**PACIFICORP
LASSEN SUBSTATION PROJECT
MINOR PROJECT REFINEMENT
REQUEST FORM**

Date Submitted:	10/12/2022	Request #:	Minor Project Refinement Request #1
Date Approval Required:	10/21/2022	Landowner:	
APN:			
Refinement from (check all that apply):			
<input type="checkbox"/> Mitigation Measure	<input type="checkbox"/> APM	<input checked="" type="checkbox"/> Project Description	<input type="checkbox"/> Drawing <input type="checkbox"/> Other
Identify source (mitigation measure, project description, etc.):			
<p>PacifiCorp plans work in areas not previously included in Project plans. Minor Project Refinement (MPR) areas are required due to changes between the preliminary design presented in Notice to Proceed (NTP)#2, final design and requirements needed by the contractor to finish construction. All Applicant Proposed Measures (APMs) and mitigation measures (MMs) defined in the Project's Mitigation Monitoring, Compliance, and Reporting Program—as well as other permit and plan conditions—will be implemented as applicable to minimize or mitigate for any additional impacts.</p>

**FIGURE 1
MINOR PROJECT
REFINEMENT #1**

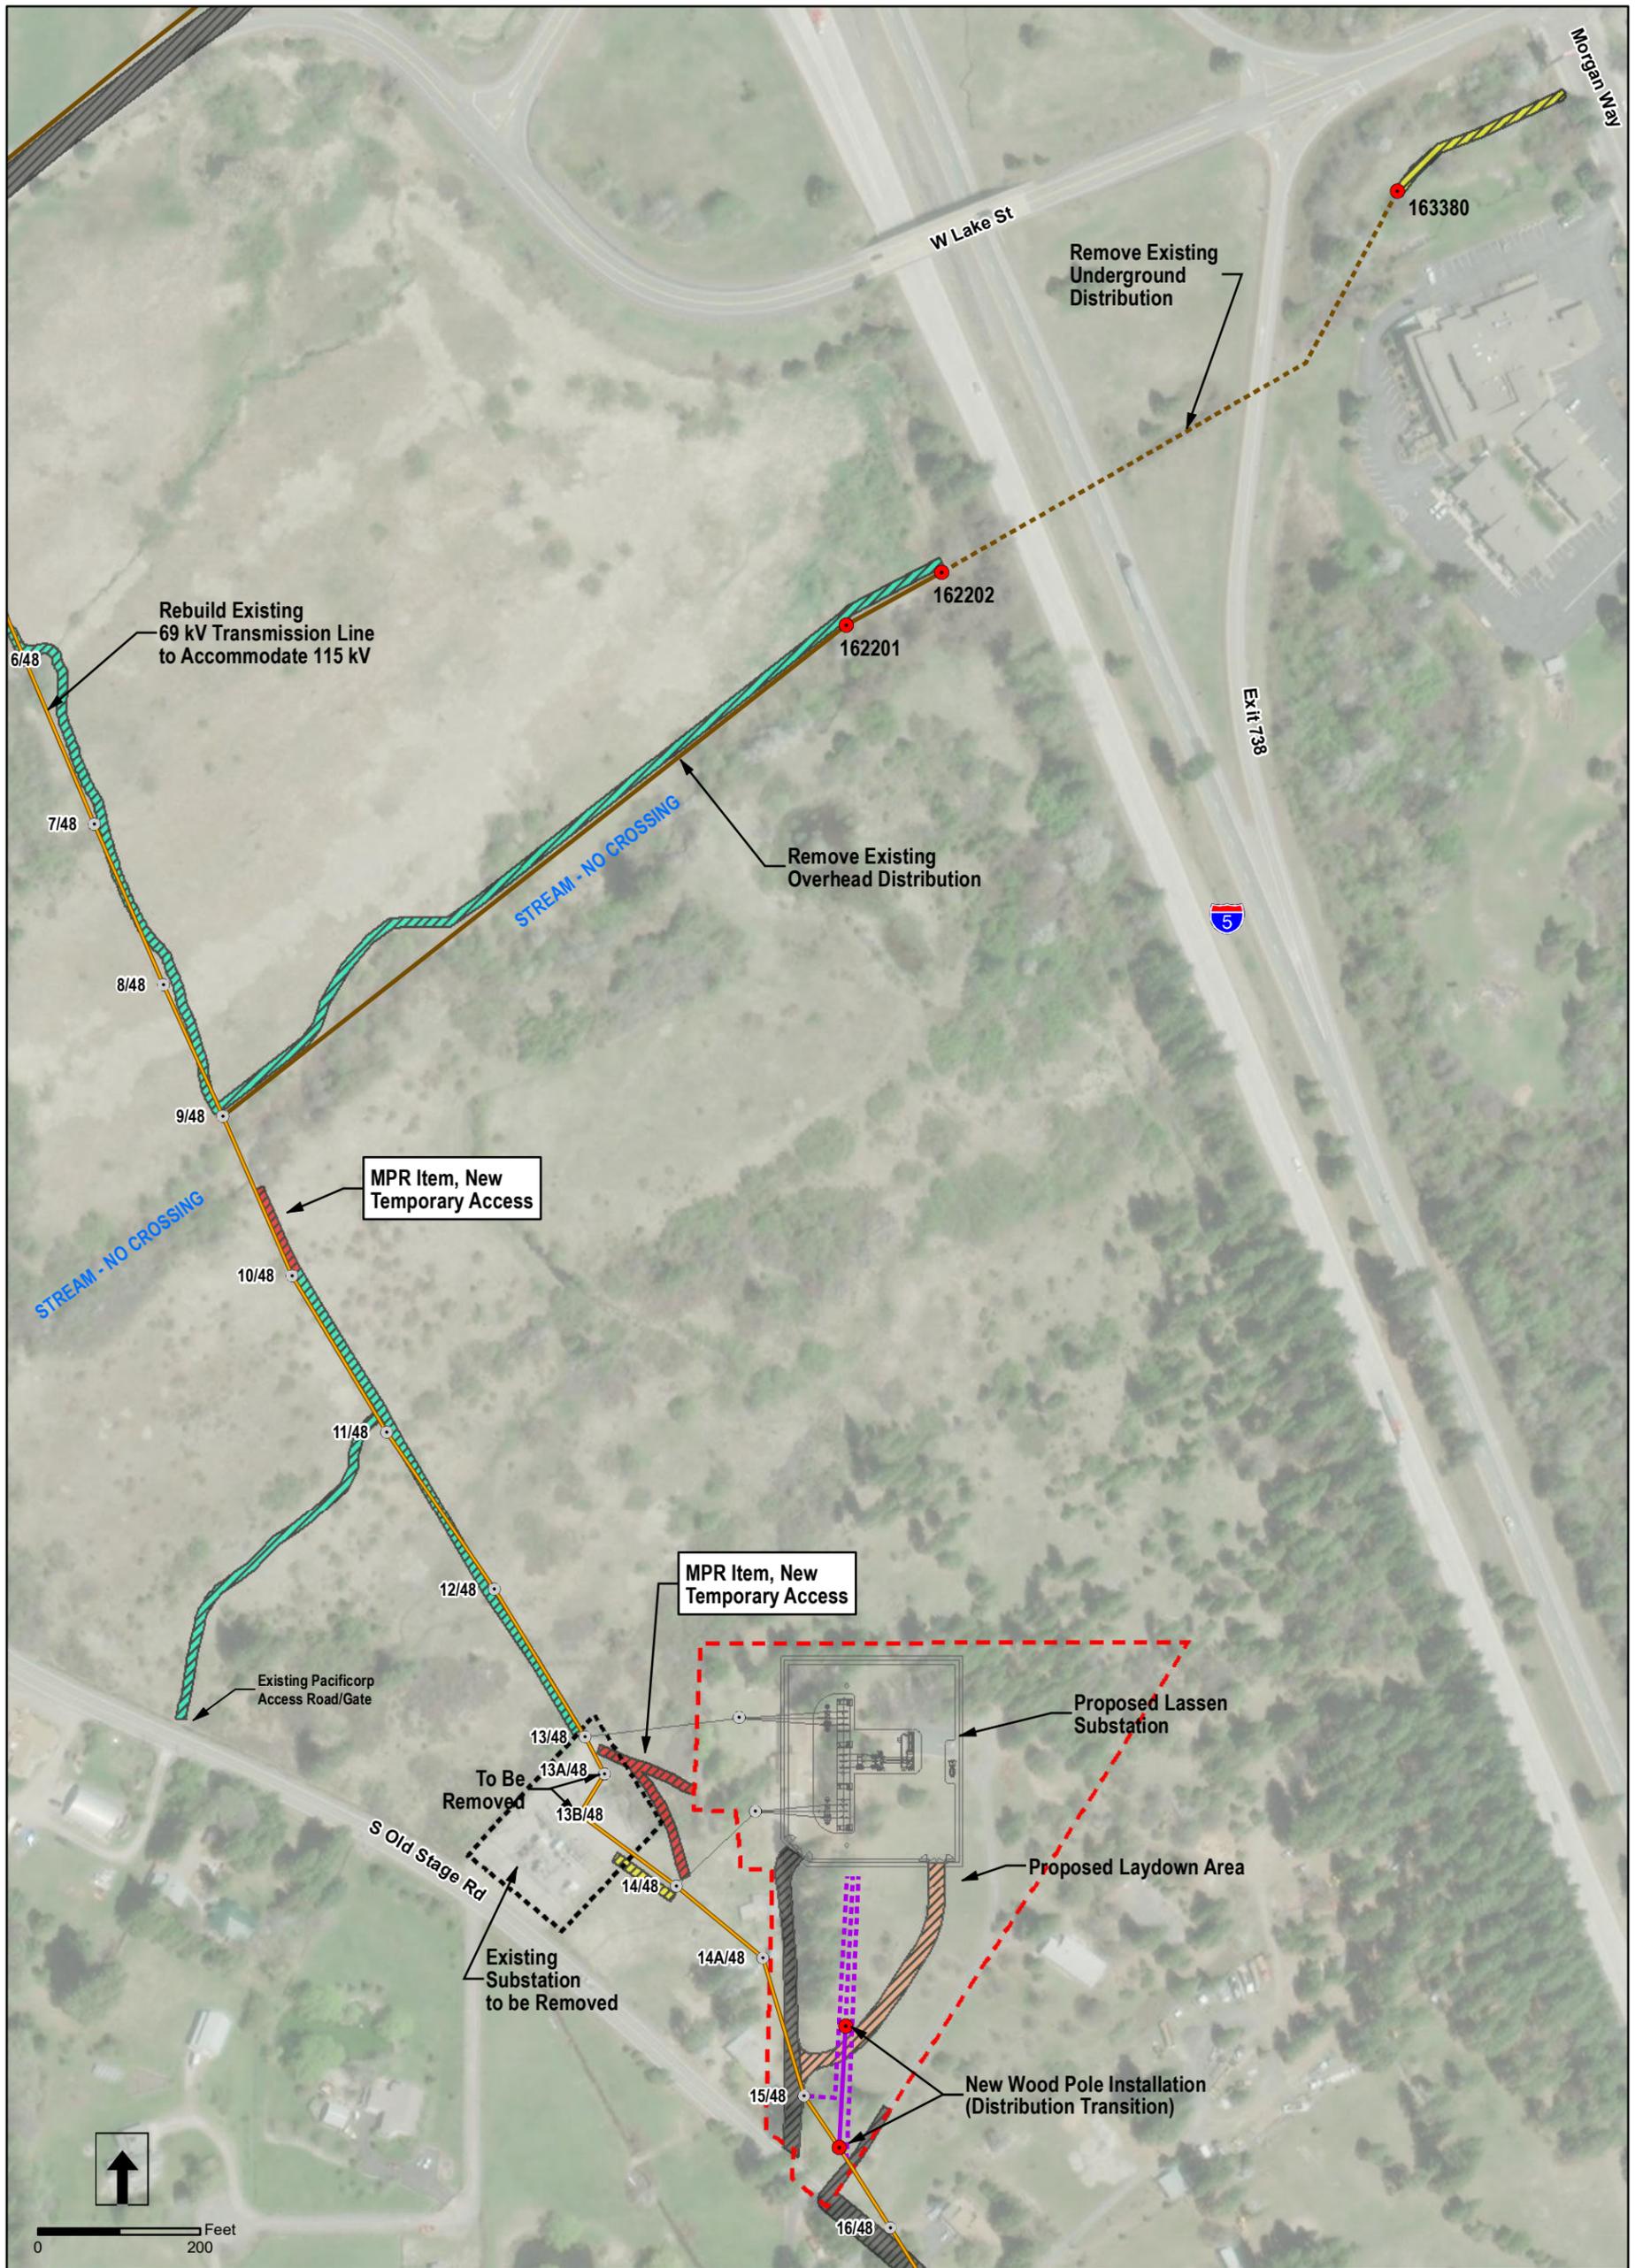
<p>(c) Does the proposed refinement conflict with any mitigation measure or applicable law or policy? No</p>			
<p>(d) Does the proposed refinement trigger an additional permit requirement? No</p>			
Describe refinement being requested (attach drawings and photos as needed):			
<p>PacifiCorp requests authorization from the CPUC for an MPR for the following activities not previously included in the NTP #2:</p> <ul style="list-style-type: none"> • In order to access pole locations between the Mt. Shasta Substation (old) and the new Lassen Substation, additional access areas are required. To avoid potential impacts from temporary access to wetland areas, high density polyethylene (HDPE) driving mats will be placed along the temporary access in accordance with APM BIO-5 (refer to Figure 1). • In order to complete work at Pole 10/48 and install necessary equipment on the transmission line, PacifiCorp needs additional temporary access area adjacent to and north of pole 10/48.

Provide need for refinement (attach drawings and photos as needed):					
The requested refinements described in this MPR are required due to changes between the design presented in NTP #2 and the final design. In order to energize the new Lassen Substation, PacifiCorp needs to make adjustments in the plans related to new access areas illustrated on Figure 1, Minor Project Refinement #1 and Attachment 1, Photographs.					
Date refinement is expected to be implemented:					
PacifiCorp Approvals					
Title	Name	Approval Initials	Date	Conditions (see attached)	
Senior Engineering/Operations Project Manager	Joseph Kathol	JK	10/12/22	<input type="checkbox"/> Yes	<input type="checkbox"/> No
				<input type="checkbox"/> Yes	<input type="checkbox"/> No
Landowner Approval (if required)					
Landowner Name		Signature or Other Consent (see attached)		Date	
N/A					
Resource Agency Coordination					
Resource Agency	Name	Action Required	Date	Documentation (see attached if yes)

To avoid potential impacts from temporary access to wetland areas, HDPE driving mats will be placed along the temporary access as indicated in Figure 1 in accordance with APM BIO-5.

Hazards and Hazardous Materials	<input checked="" type="checkbox"/>	<input type="checkbox"/>	<input type="checkbox"/>
The requested MPRs would not change the routine transport, use, and disposal of hazardous materials or the fire risk analyzed in the IS/MND. The requested refinements would not result in a new significant impact or a substantial increase in the severity of a previously analyzed impact to hazards and hazardous materials as identified in the IS/MND.			
Hydrology and Water Quality	<input checked="" type="checkbox"/>	<input type="checkbox"/>	<input type="checkbox"/>
The requested MPRs would not alter impacts related to water quality, groundwater resources, would not alter existing drainage patterns, would not contribute to runoff, or expose people of structures to flood hazards analyzed in the IS/MND. The requested refinements would not result in a new significant impact or a substantial increase in the severity of a previously analyzed impact to hydrology and water quality identified in the IS/MND. To avoid potential impacts from temporary access to wetland areas, HDPE driving mats will be placed along the temporary access in accordance with APM BIO-5 (refer to Figure 1).
